SITE2022-01  
#8571

# Riverside Station Apartments

## Drainage Report

FIGURE  
A-6

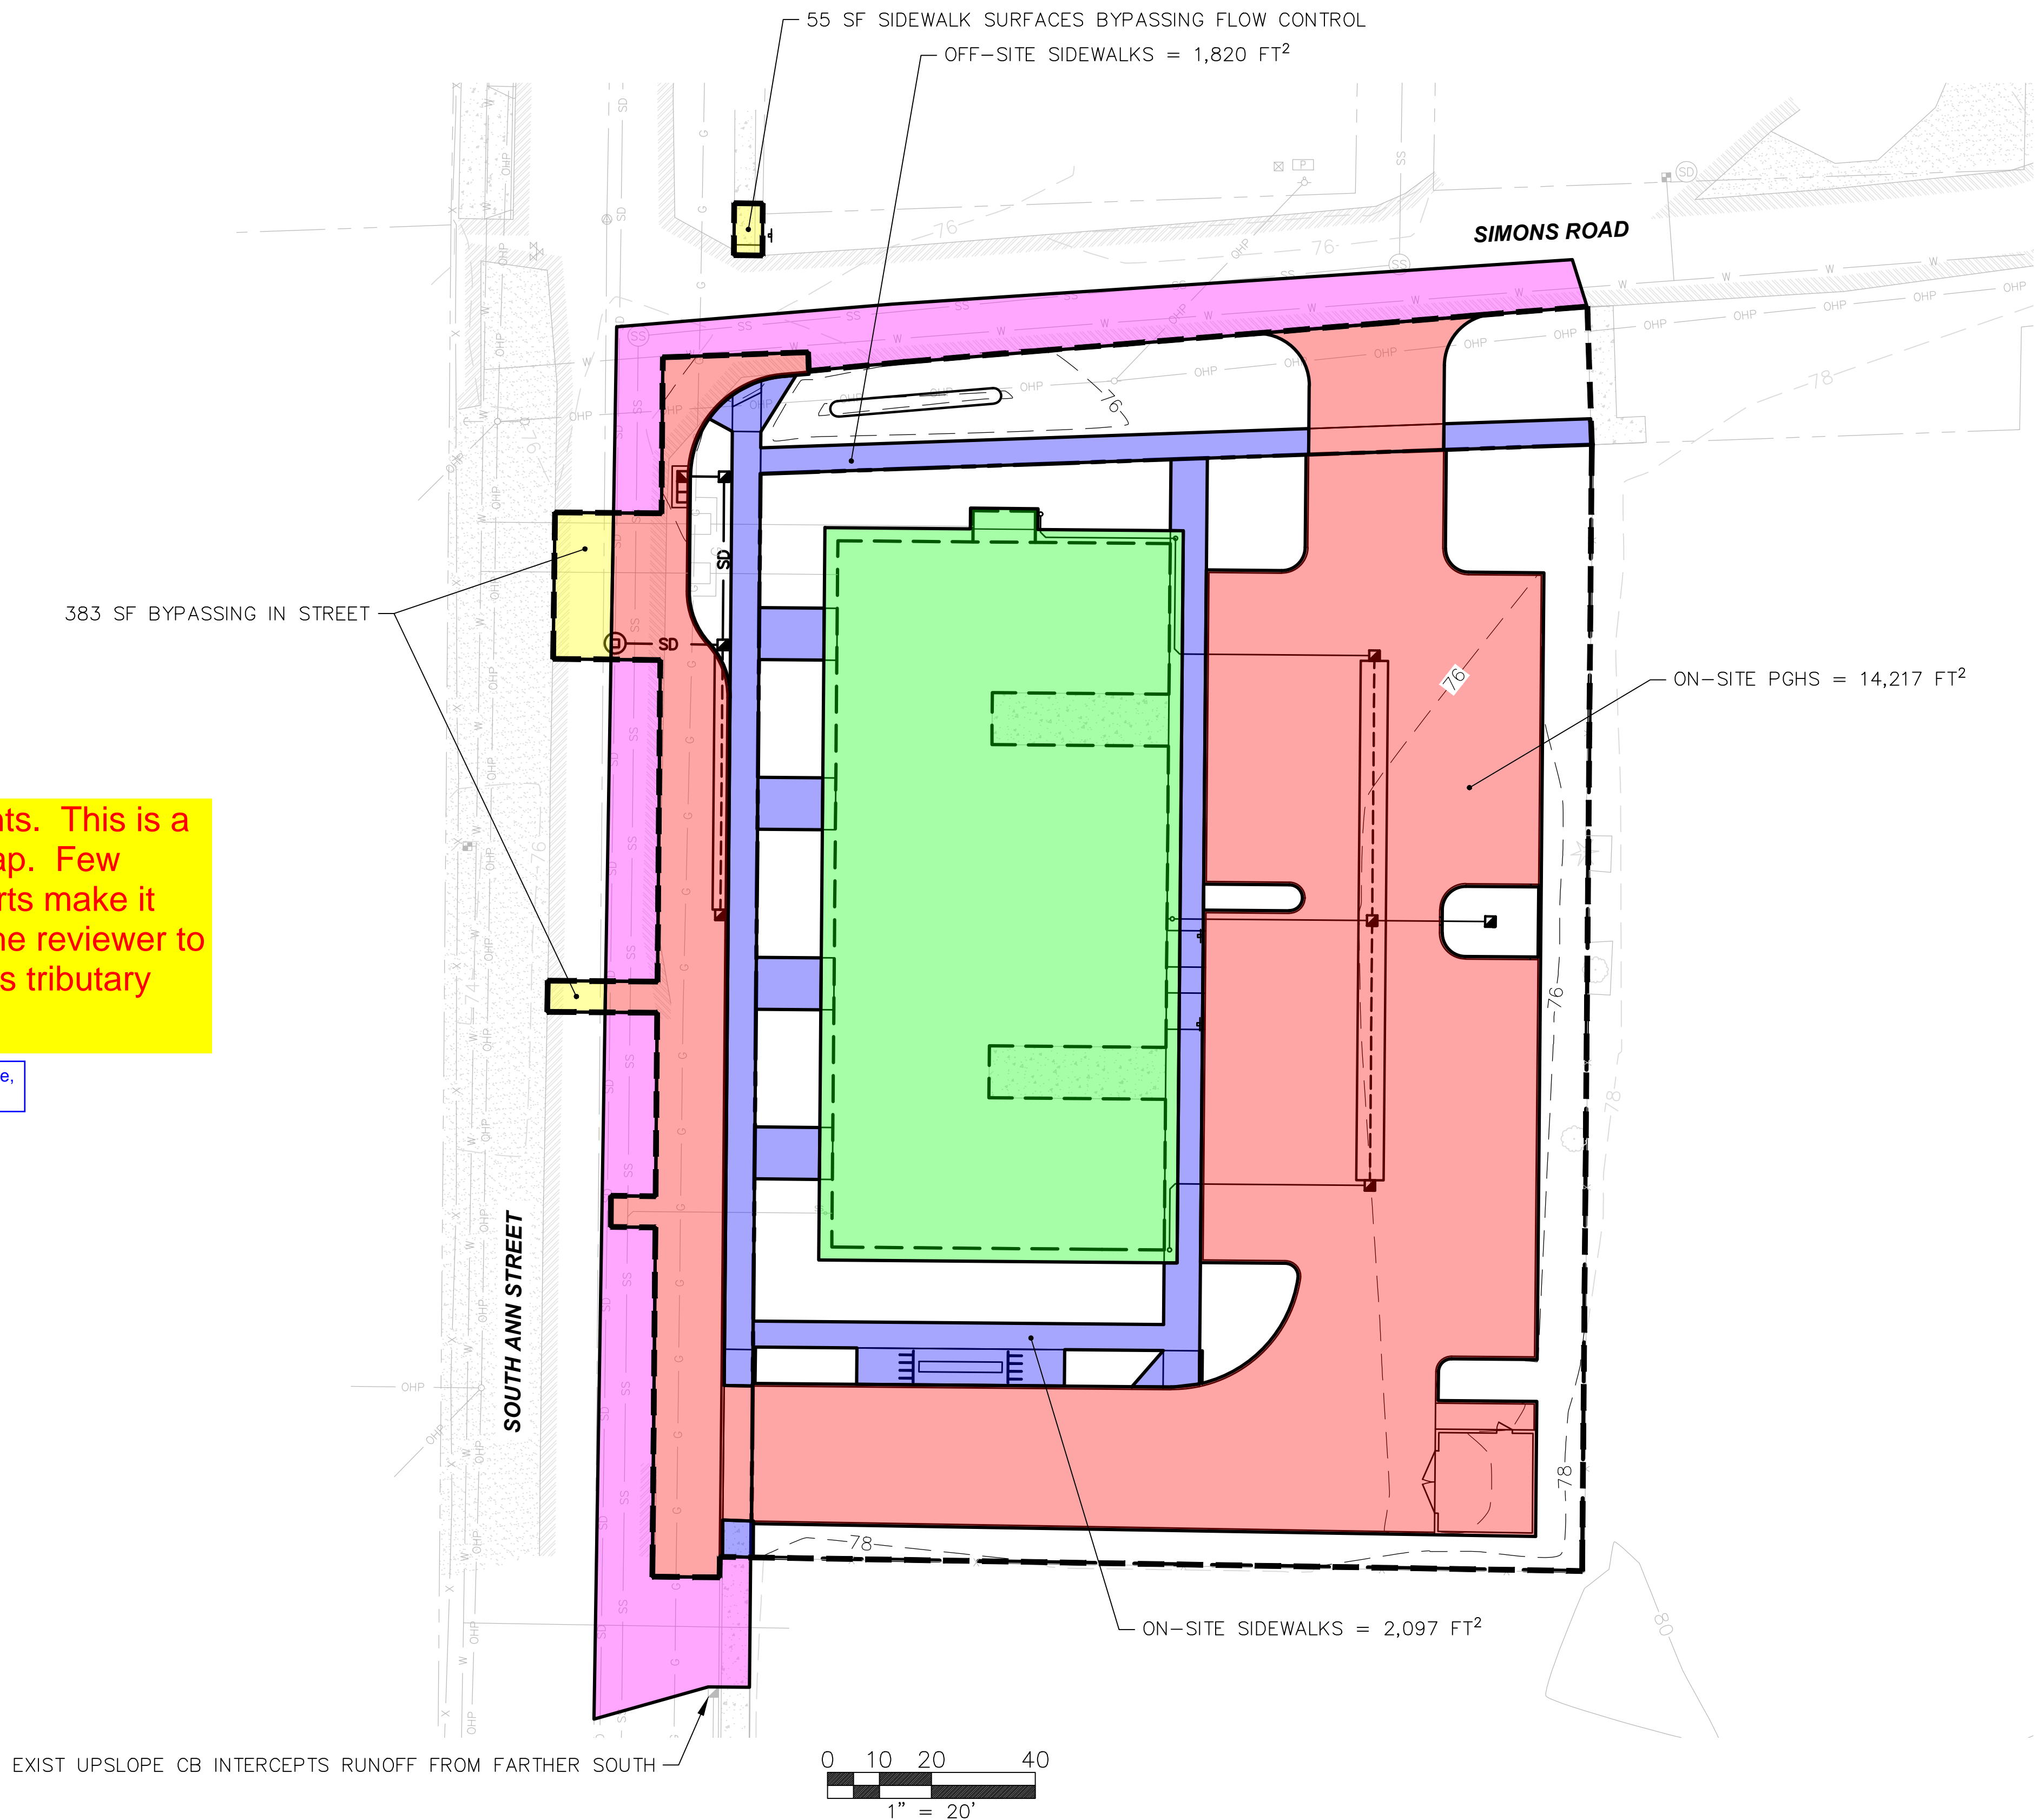
**My compliments. This is a very useful map. Few drainage reports make it this easy for the reviewer to see the various tributary areas.**

Thank you. Lots of practice, what can I say?
